Add CCC approval mark and change to ENEC10 approval mark.

Product Change Notification					4752 change of marking		
owner	creation date	release date	released by	change order no	rev	page	D10-047-584
sariogar	14.08.2020	20.05.2021	muehlema	2020349	A	1 of 2

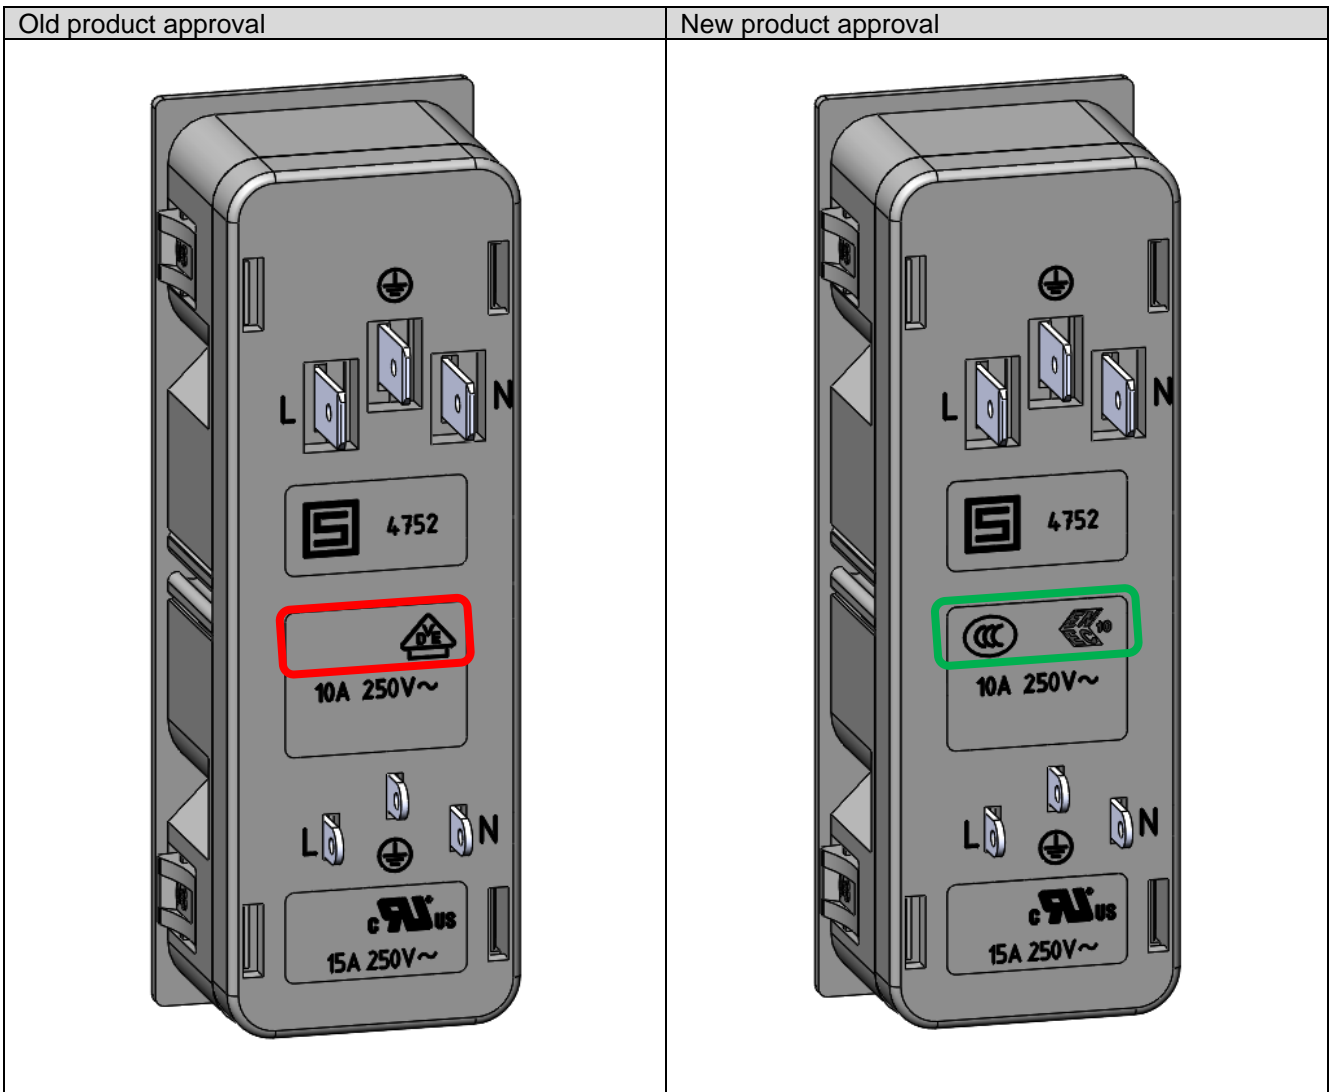
Received the Chinese CCC Approval certificate for product type 4752 and replaced the VDE approval mark with ENEC10.

Form	Yes	New CCC and ENEC10 approvals marking added to cover
Fit	No	-
Function	No	-
Manufacturing	No	-
Label	Yes	Approvals markings added to packaging label
Packaging	No	-
